**ANB4 - Retrofitting Locking Caps on the Front Left and Right Headlights (Stop Delivery / Recall Campaign)**

Model Line: **Carrera GT (980)**

Concerns: **Caps on headlight**

*Installation position of caps*

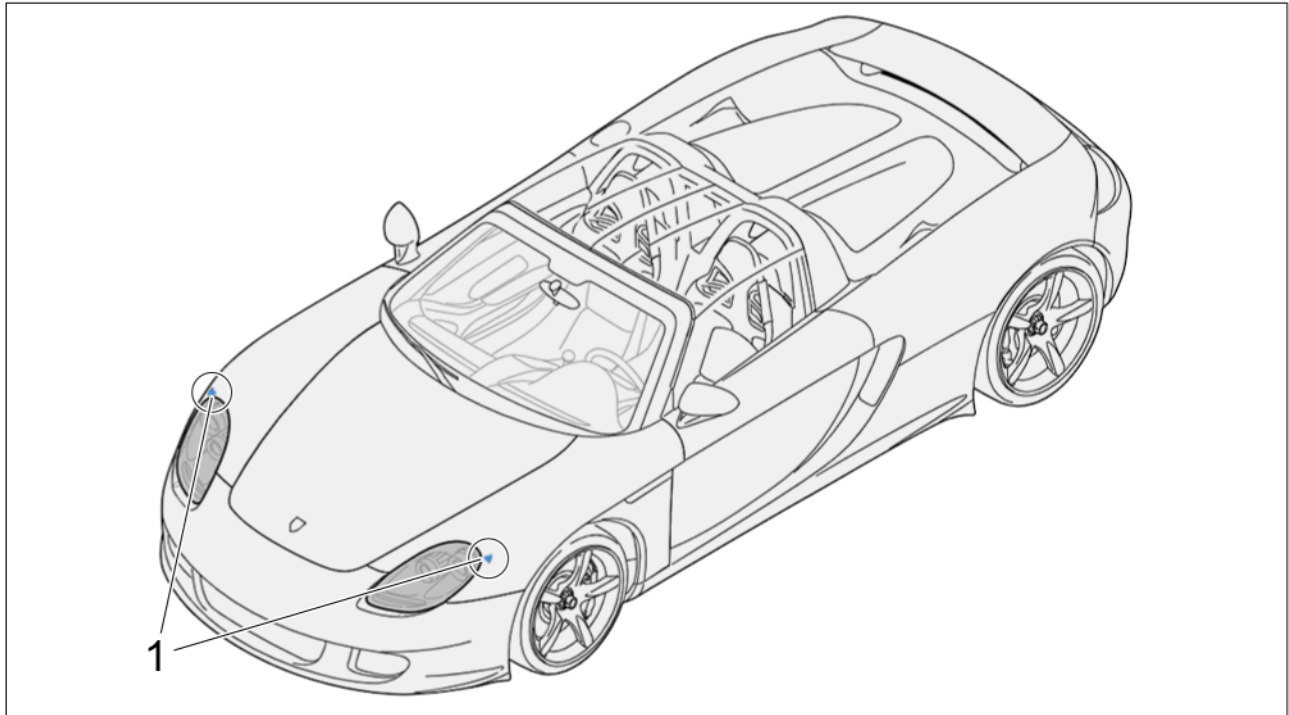
Information: **There is a possibility that a locking cap that prevents the adjustment of the headlights in the horizontal direction was not installed during vehicle assembly on the affected vehicles. If this is the case, certain legal requirements will not be met in the USA and Canada markets.**

Action required: Check installation of the caps and retrofit a cap on the adjusting screw for horizontal adjustment on the left and right headlights if necessary.

1 – Caps (retrofit)

*Installing cap (e.g. left headlight)*

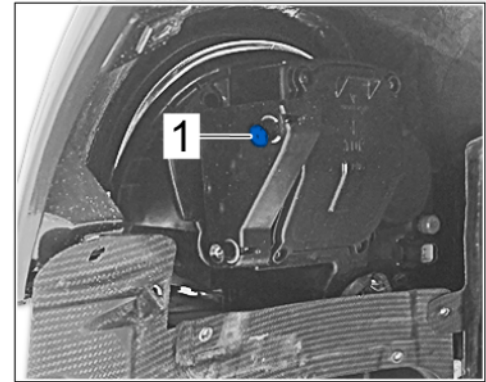
- 4 Check that a cap is installed on the adjusting screw for the horizontal adjustment on the left and right headlight. ⇒ *Checking sealing caps*

Assessment		Action
(✓)	A cap is installed on the left and right headlight.	End of remedial action. Continue with Step 6.
(✗)	There is <b>no</b> cap or only one <b>cap</b> installed on <b>one</b> headlight.	Retrofit cap. Continue with Step 5.

- 5 Press the cap on the left and right headlight into the adjusting screw for horizontal adjustment.
- 6 Install section of front wheel housing liners **A**.  
For instructions, see Workshop Manual: **505619 Removing and installing wheel housing liner front**
- 7 Install wheels on the front axle.  
For instructions, see Workshop Manual: **440519 Removing and installing wheel**
- 8 Lower vehicle.  
For instructions, see Workshop Manual: **OX00IN Lifting vehicle**
- 9 Enter the campaign in the Warranty and Maintenance booklet.
